Well Name: POKER LAKE UNIT 13-24 PC	Well Location: T24S / R29E / SEC 13 / SWNE /	County or Parish/State:
Well Number: 125H	Type of Well: CONVENTIONAL GAS WELL	Allottee or Tribe Name:
Lease Number: NMNM005912	Unit or CA Name:	Unit or CA Number: NMNM71016X
US Well Number: 3001553555	Well Status: Approved Application for Permit to Drill	Operator: XTO PERMIAN OPERATING LLC

Sundry ID: 2745200

OPERATOR'S NAME:	XTO Energy Inc
WELL NAME & NO.:	Poker Lake Unit 13-24 PC 125H
LOCATION:	Sec 13-24S-29E-NMP
COUNTY:	Eddy County, New Mexico

*Changes approved through engineering via **Sundry 2745200** on 09/01/2023. Any previous COAs not addressed within the updated COAs still apply.*

WELL LOCATION AND ACREAGE DEDICATION PLAT

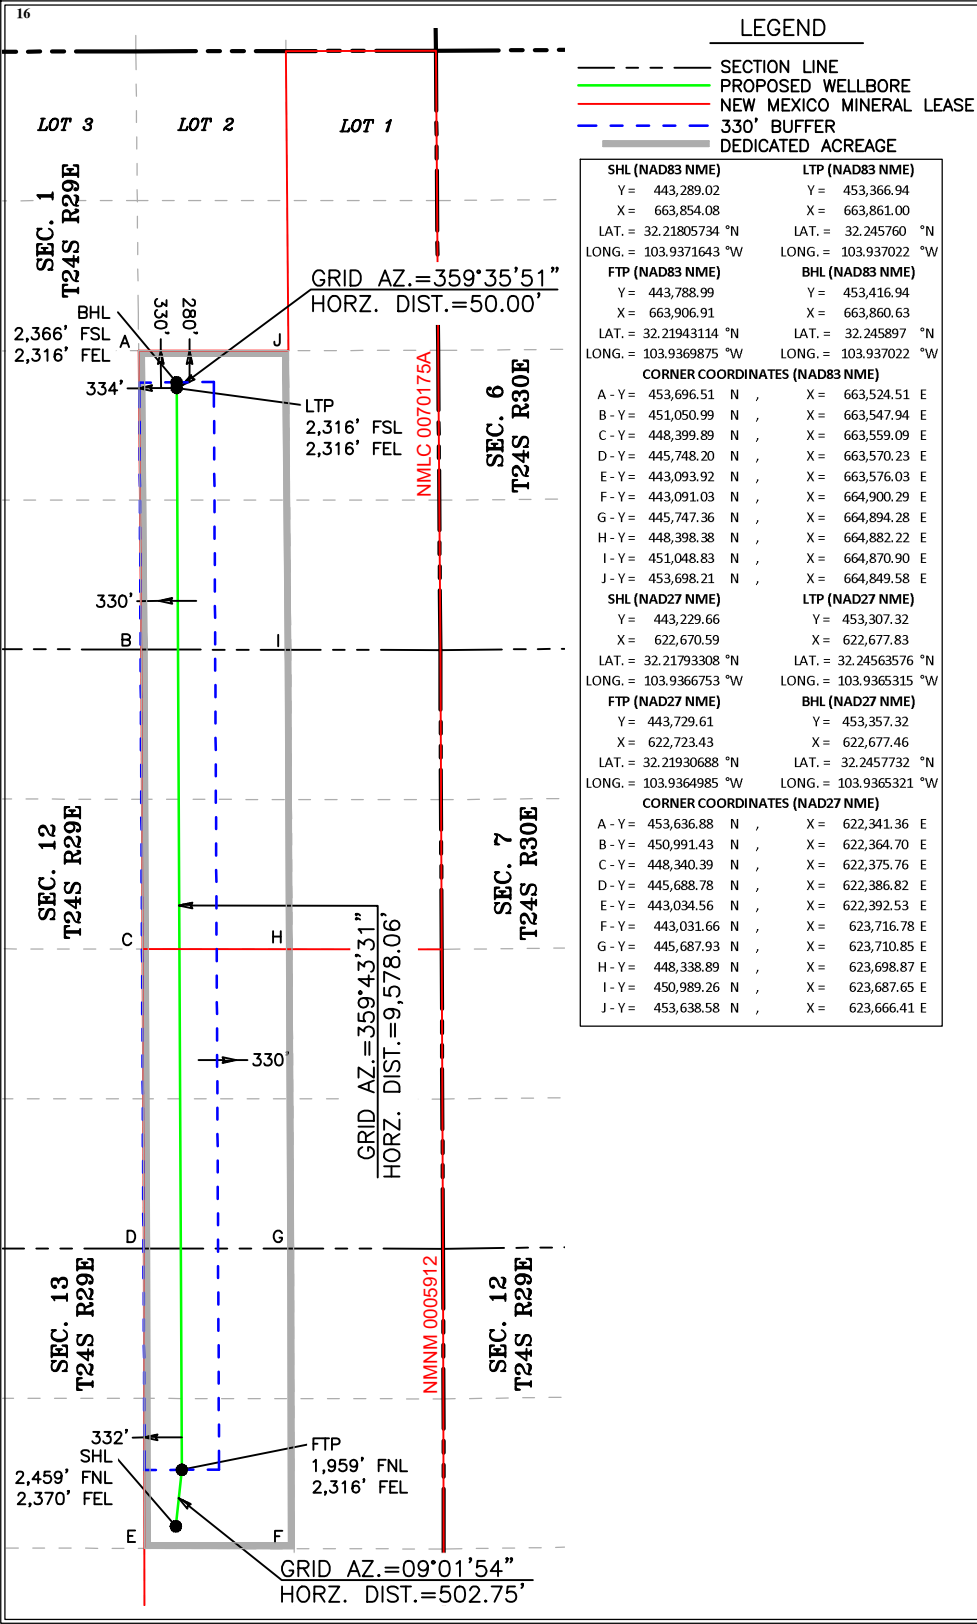
SHL: fr/2384FNL & 2445FEL to 2459FNL & 2370FEL, NMNM05912

FTP: fr/2740FNL & 2310FEL to 1959FNL & 2316FEL, NMNM05912

LTP: fr/330FSL & 2310FEL to 2316FSL & 2316FEL, NMLC0696005A

BHL: fr/200FSL & 2310FEL to 2366FSL & 2316FEL, Section 1-T24S-R29E NMLC0696005A

UL or lot no.	Section	Township	Range	Lot Idn	Feet from the	North/South line	Feet from the	East/West line	County
G	13	24 S	29 E		2,459	NORTH	2,370	EAST	EDDY

UL or lot no.	Section	Township	Range	Lot Idn	Feet from the	North/South line	Feet from the	East/West line	County
J	1	24 S	29 E		2,366	SOUTH	2,316	EAST	EDDY
